File No.: 2026-099

Re: **Request for Access to Records under the Freedom of Information and Protection of Privacy Act (the "Act")**

The following records for 2212 W 10th Avenue:

Title: Land Administration and Planning - Rezoning - Rezoning Enquiry Case Files - 2202-2212 W 10th Ave - Rezoning Enquiry - PS-2024-00001

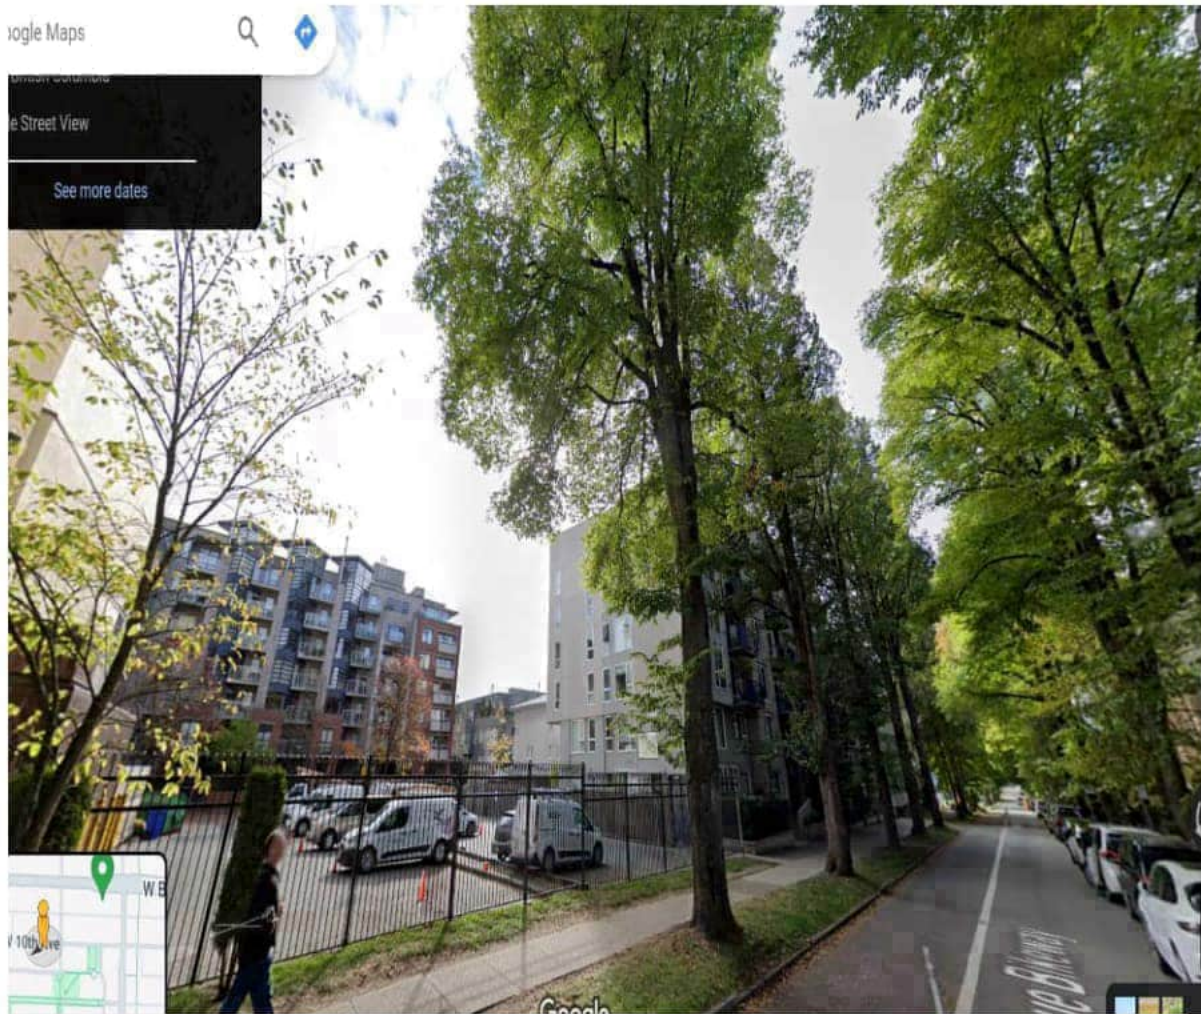
The trees are 75 ft tall with characteristic V-shaped multi stem canopy shape composed of few large, finger like main stems attached mid-point on the main stem .

Because there are not many main scaffold stems and they are proportionately large in size, pruning or "heading" back one single stem can pose a significant injury to the tree.

I am actually most concerned about the large elm next to the existing paved lot.

The roots may have grown into the parking lot. If they have, the tree will suffer root loss, and needs attention by arborist and Park Board.

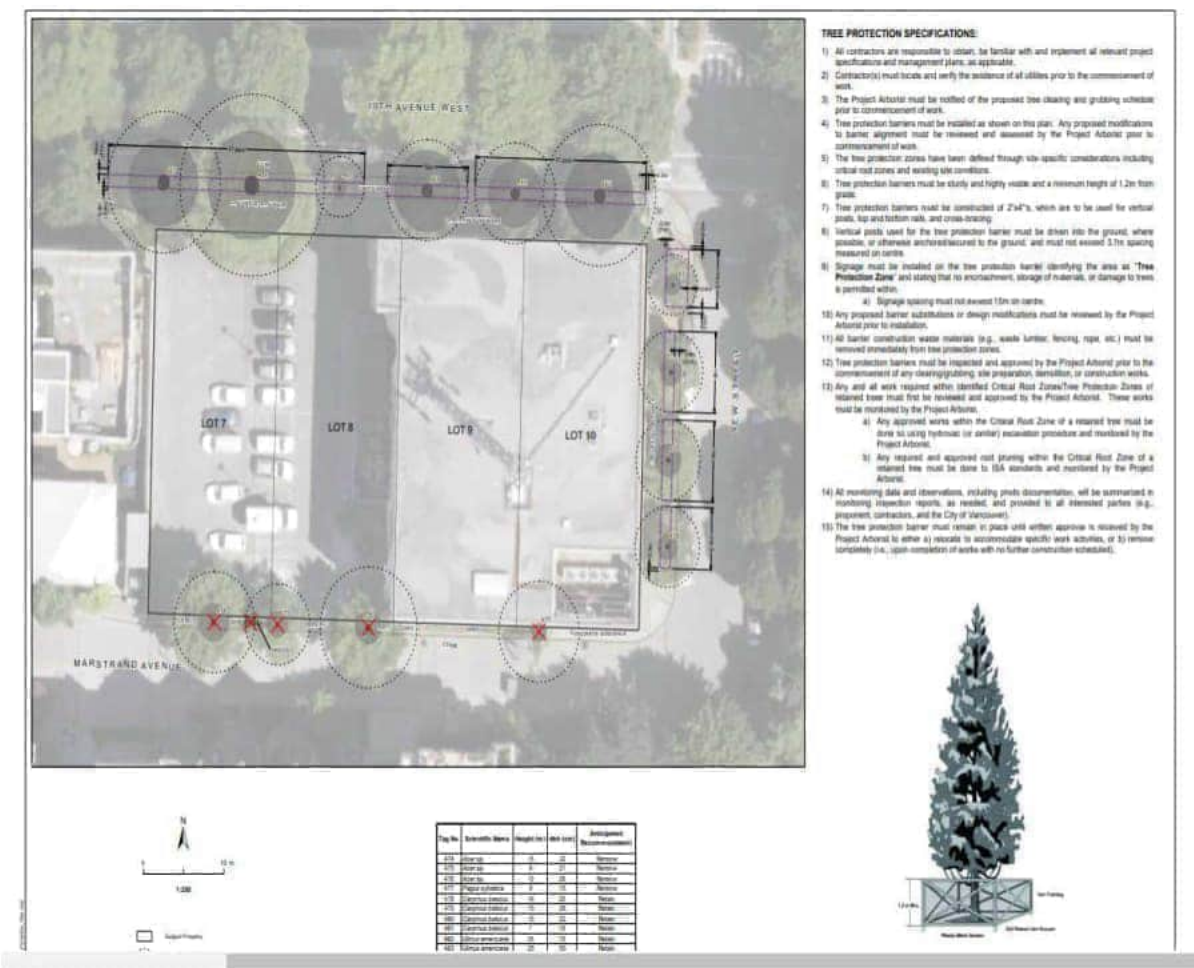
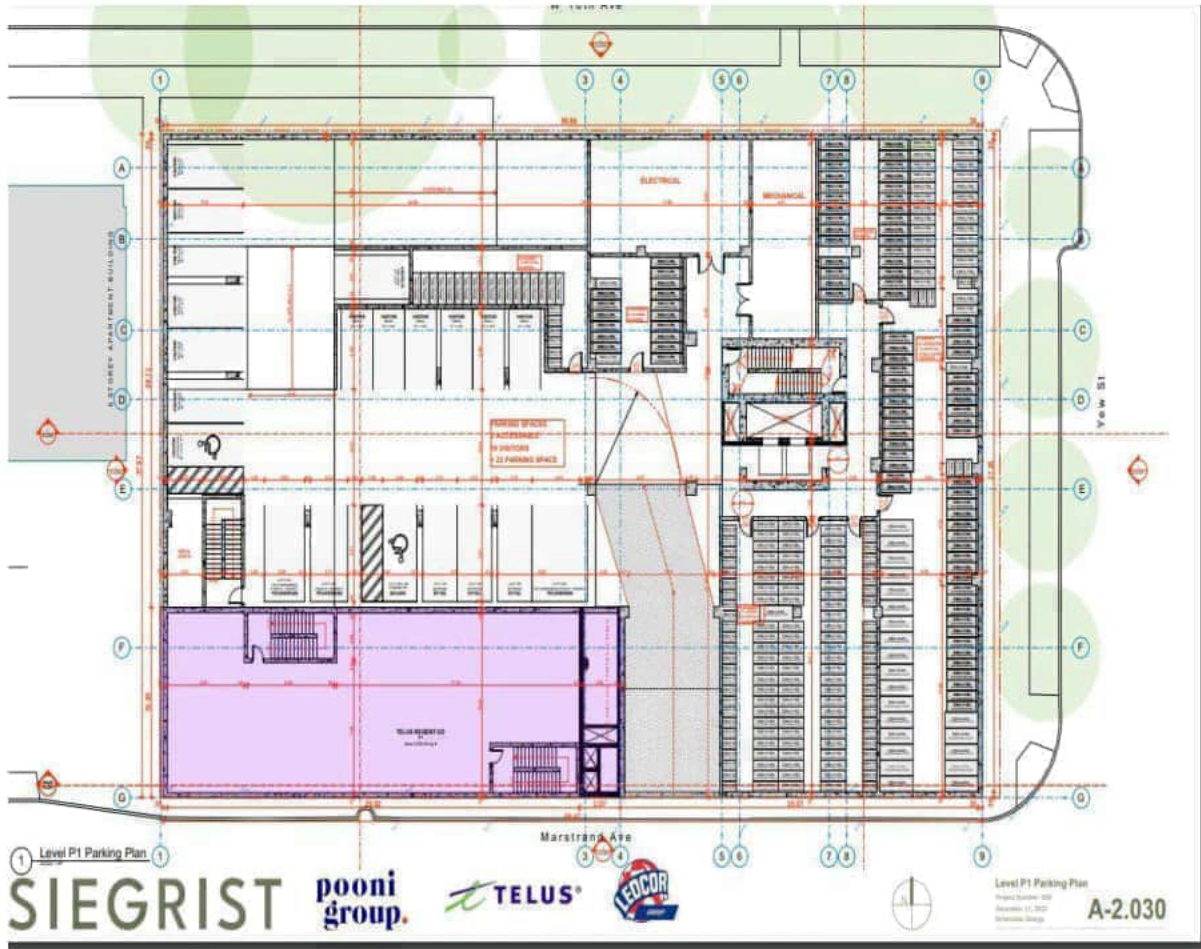
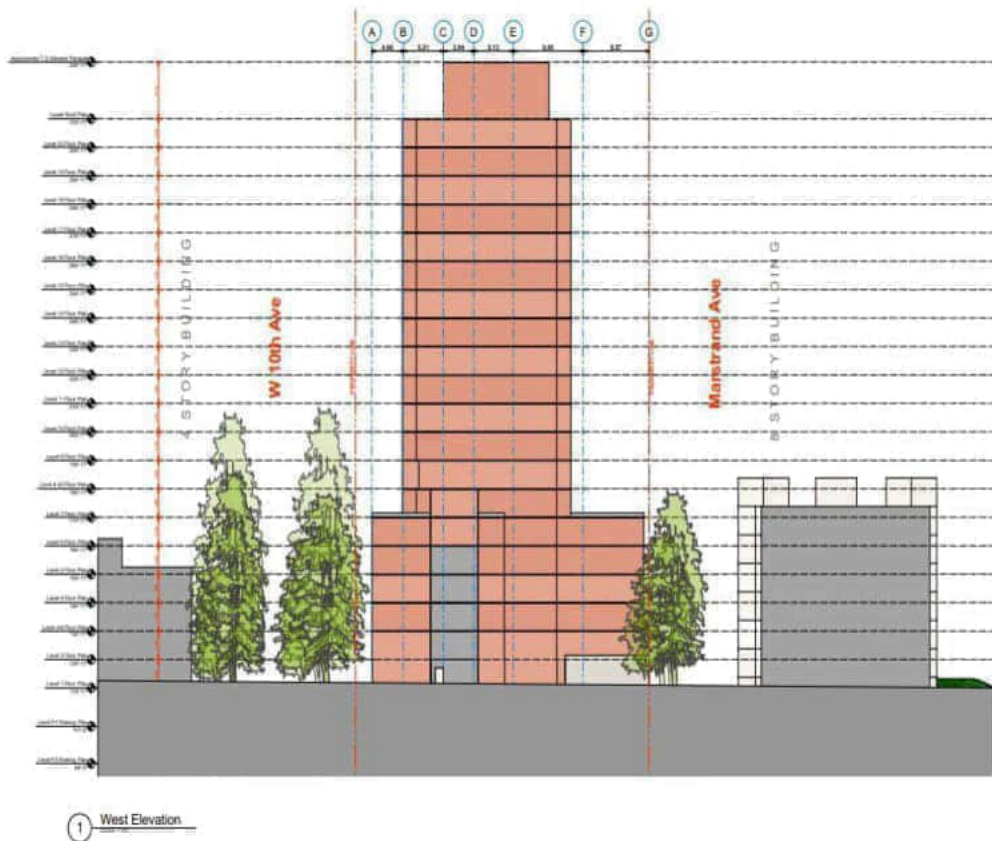
The Broadway Plan 12 ft. building setbacks do not apply for this site, which presents a problem. See below the tree management plan, the P1 plan, and a section through 10th.

The arborist report states that roots are likely constrained but is not clear why that assumption was made.

I did not see any evidence in the report that they carried out any root mapping.

The canopies may also conflict with the future building façade, since the existing canopy extends into the site.

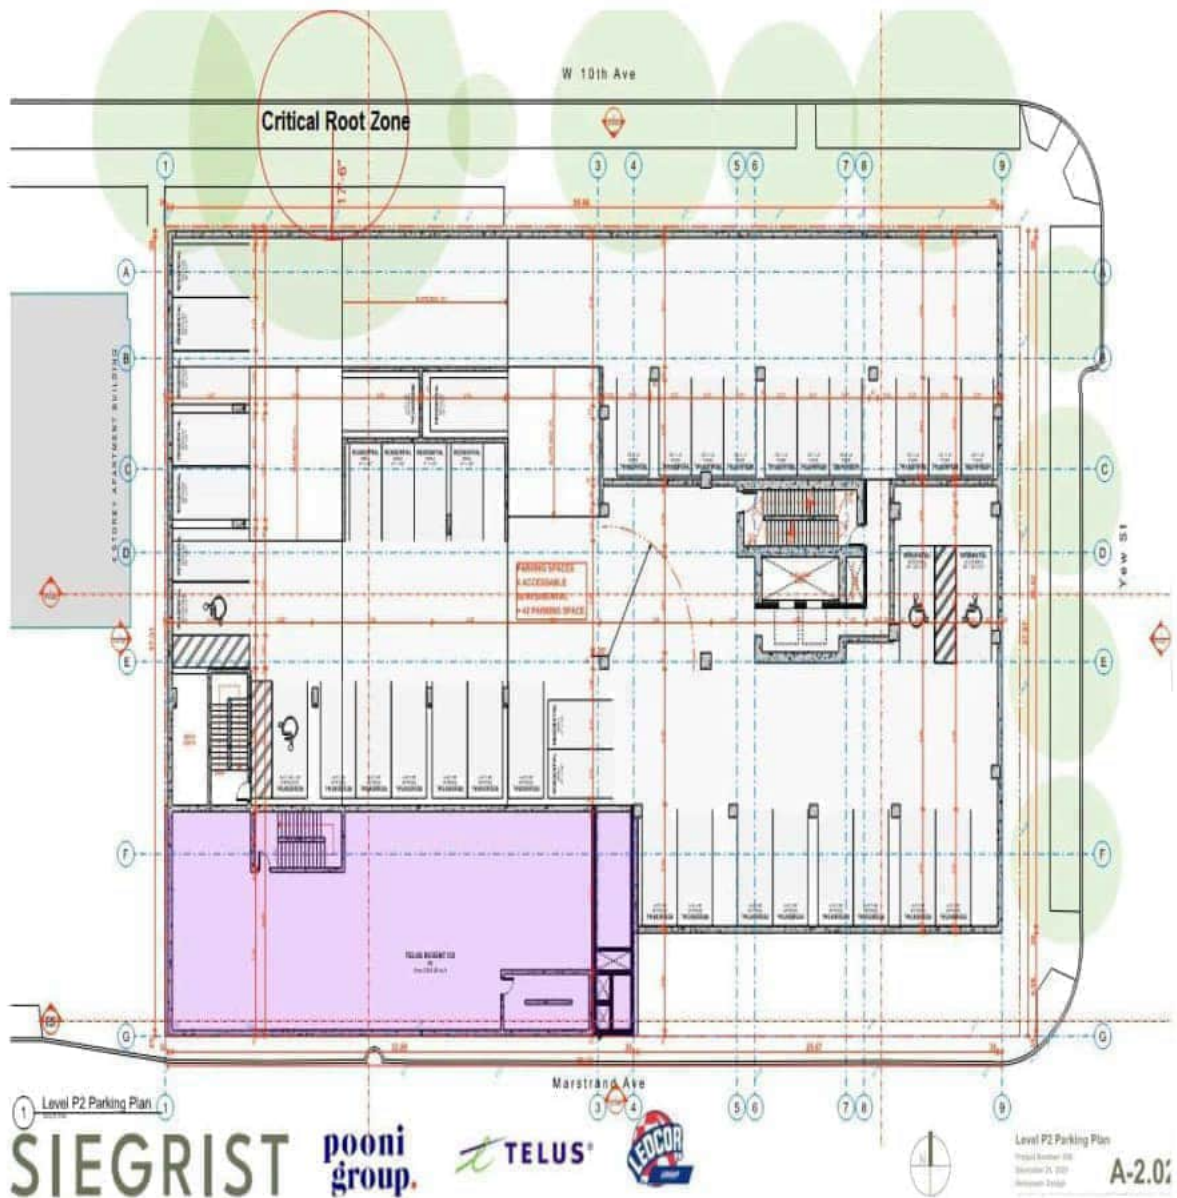
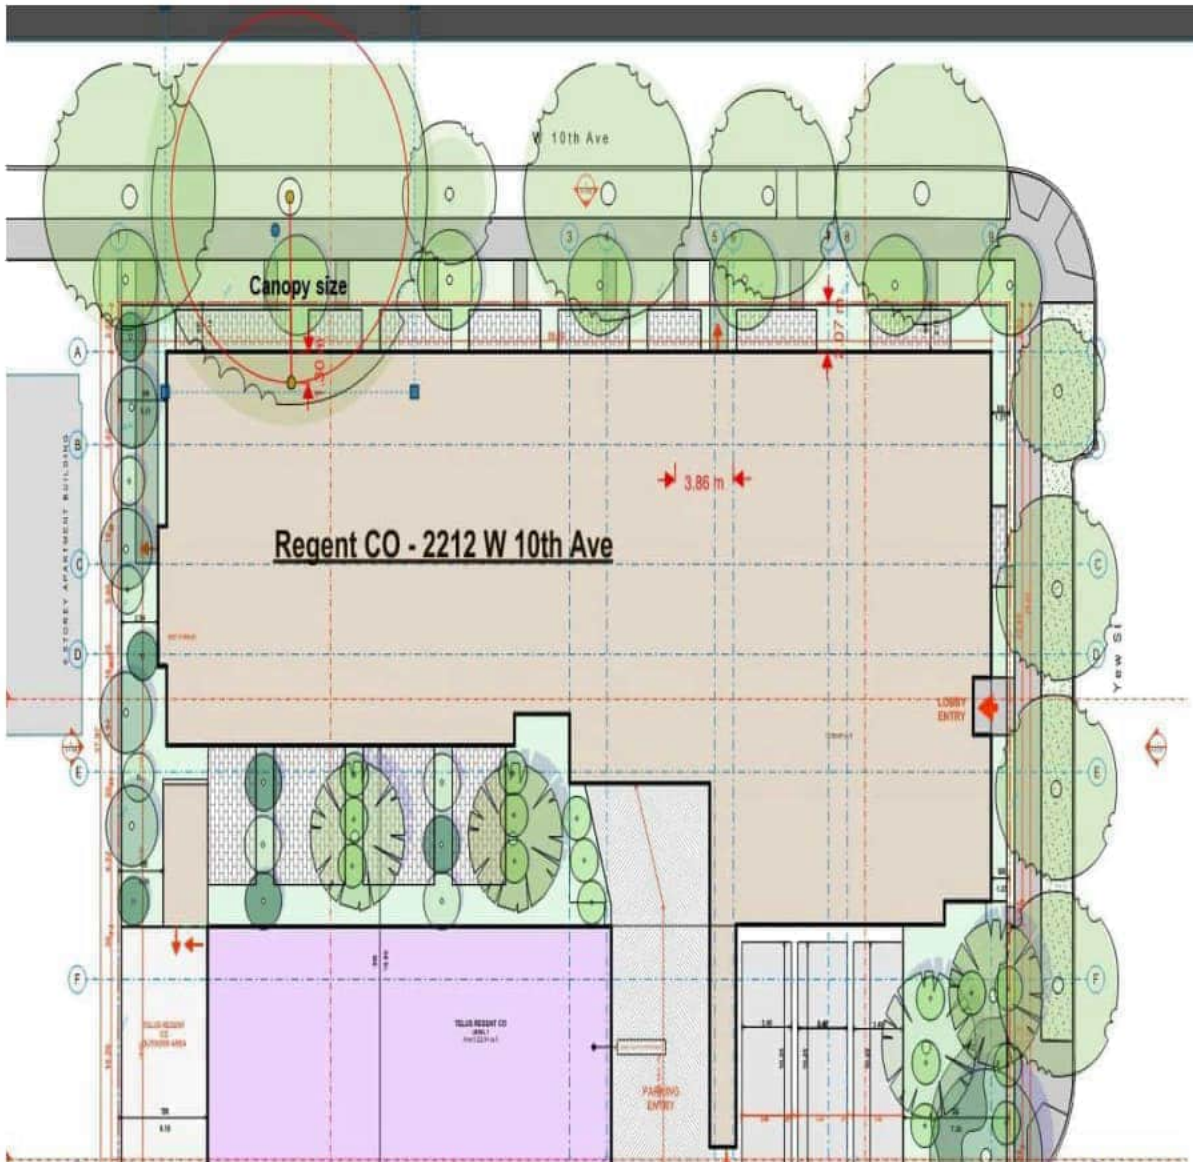
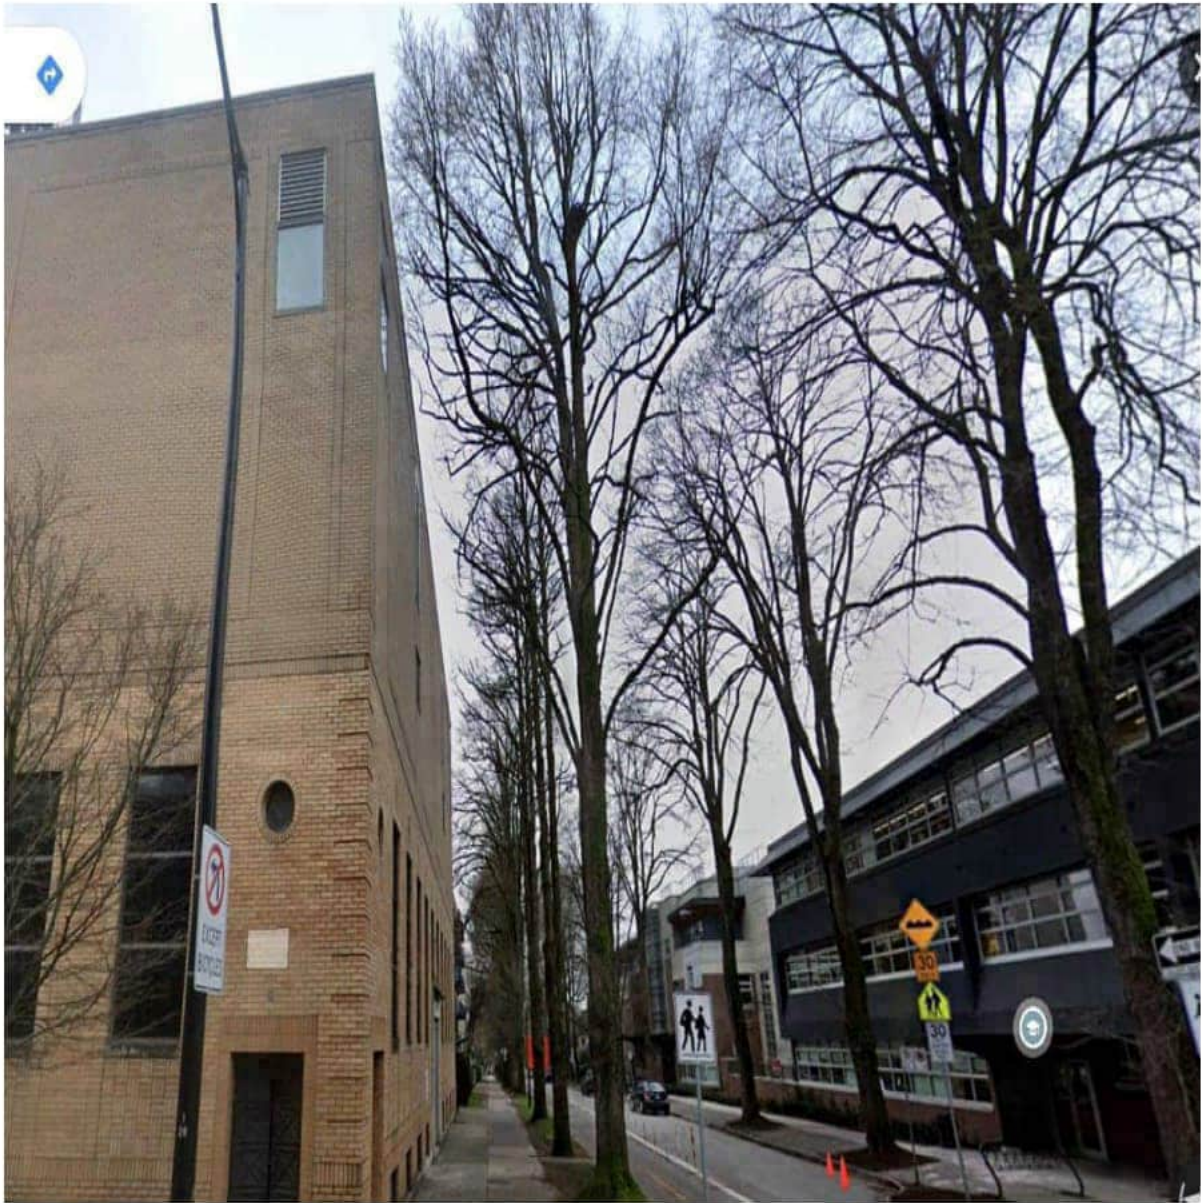
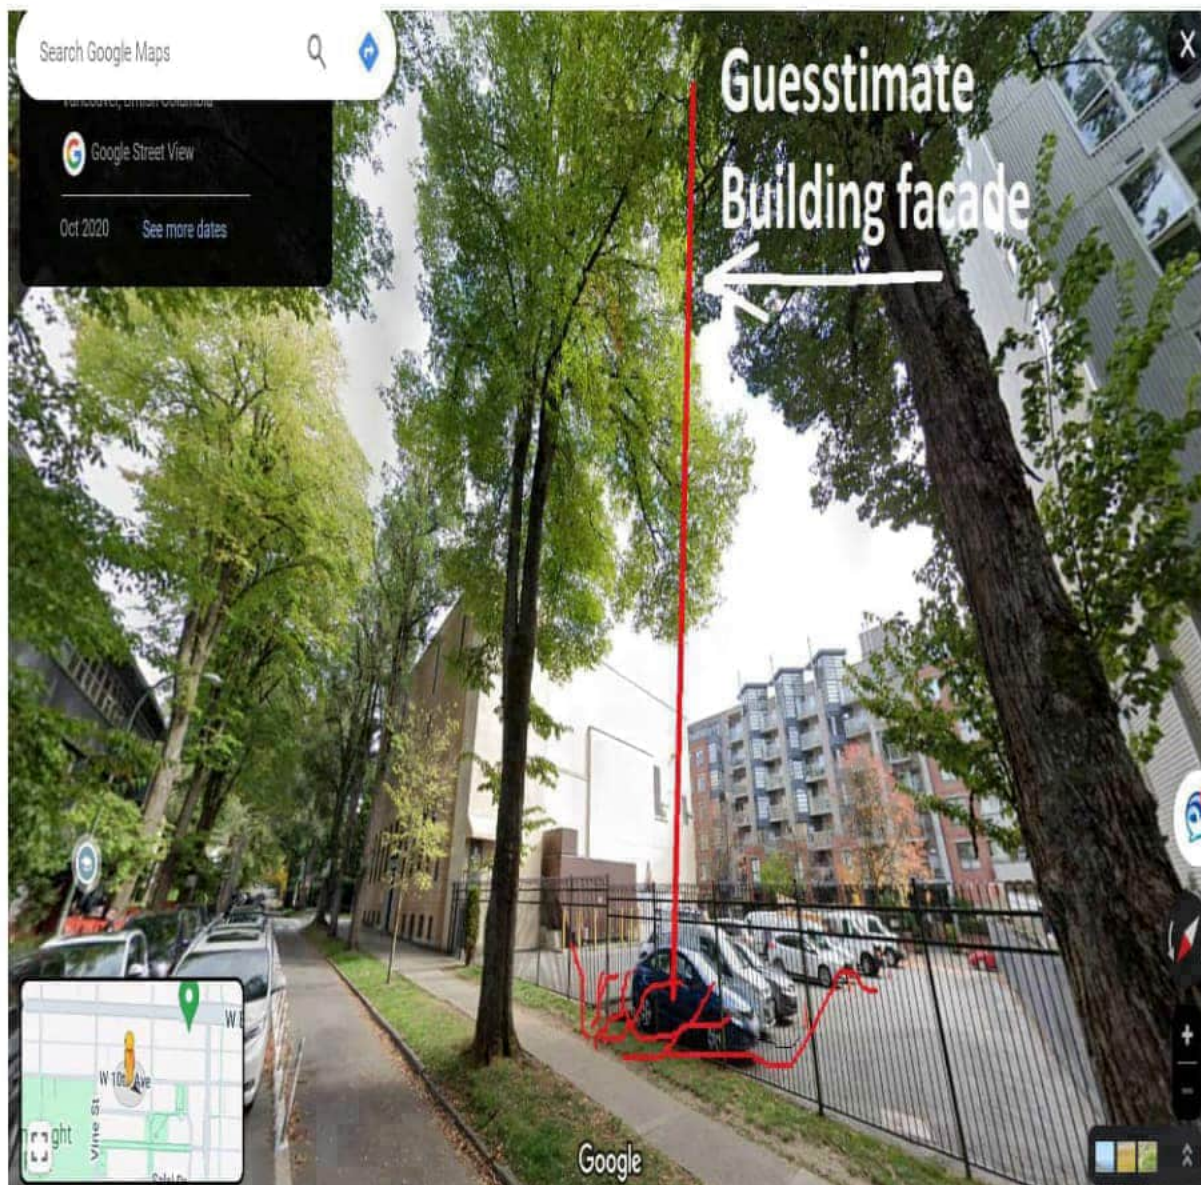
Urban Forestry supports small underground setbacks of at least 1m due to the fact that parkade membranes need repair 20 to 30 years later and the only way to access the parkade wall is excavation on city property. We have had serious impacts to large high value trees during these repair jobs as excavation occurs on city property often in the critical root zone of large trees. A 1m underground setback allows repairs to take place on private property and provides an additional 1m buffer for the street tree critical root zones.

On this site a 1m under ground setback would eliminate the need for an exploratory excavation around tree 486. The above ground set back seems to be around 2m not including balconies if there are any. There will be some pruning required as an additional 2m is usually required to facilitate façade construction. An additional 1m above ground setback would reduced the level of pruning required and minimize the tree canopy damage associated with these large builds.
